Application No:	17/00595/FULM
Proposal	Residential development of 305no 2, 3 and 4 bed dwellings and associated open space and ancillary works
Location	Land North Of Petersmith Drive, Ollerton, Nottinghamshire
Applicant	Gleeson Regeneration Ltd
Registered	10.04.2017
	Target Date: 10.07.2017
	Extension of time: Agreed until 11th May 2018

This application has been referred to Planning Committee for determination due to the officer recommendation being contrary to the comments of the Town Council.

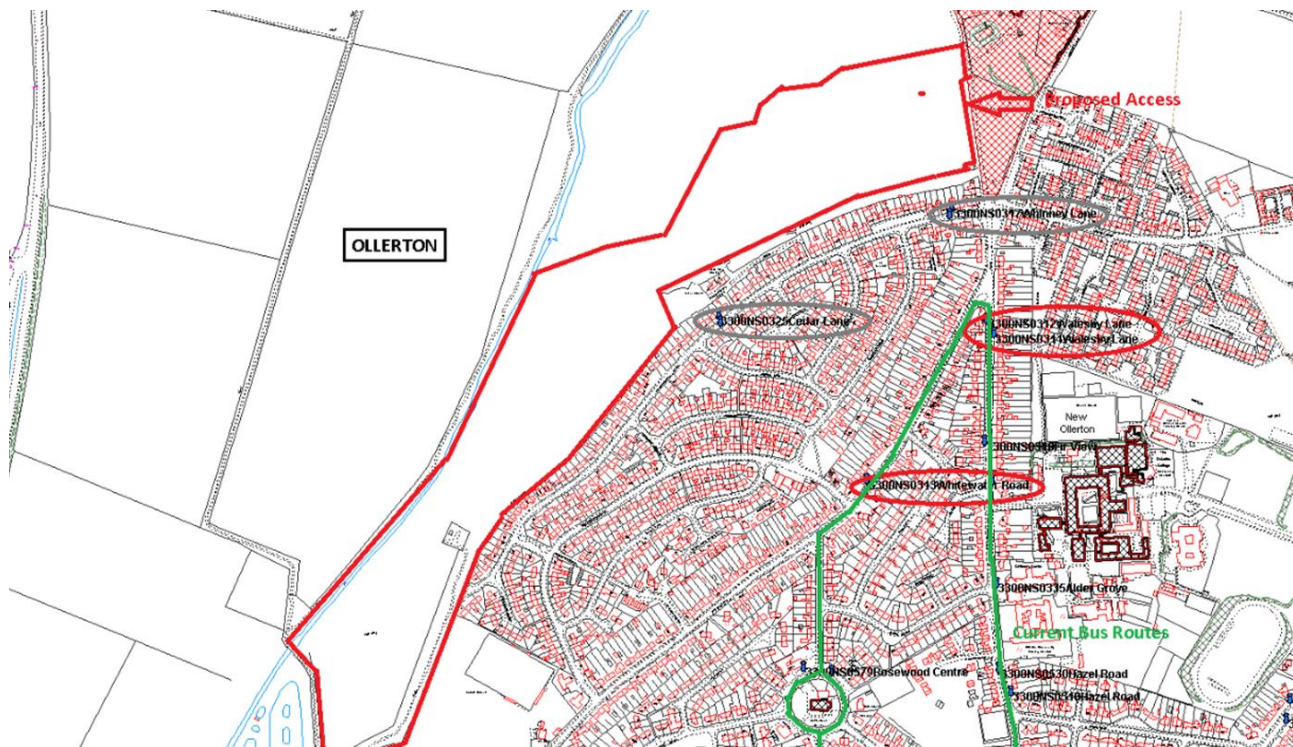
The following comments were also received on 03.04.18 in response to the applicant regarding bus provision:

'Gleeson's comments: "Firstly the bus stop distances could be reduced by providing a new bus stop at the junction of Whitewater Road and Walesby Lane. This would reduce the walking distance from the edge of the site by some 150-200m depending on exactly where the current bus stop is. Likewise a new bus stop could be positioned at the junction of Walesby Lane and Whinney Lane again reducing walking distances by a similar distance."

Transport & Travel Services Response: The attached map shows the current closest bus stops to the site and the current bus routes. Transport Facilities colleagues are unable to identify any locations for new bus stops closer to the site on those routes. Please can the developer to mark on the attached map their suggested locations?
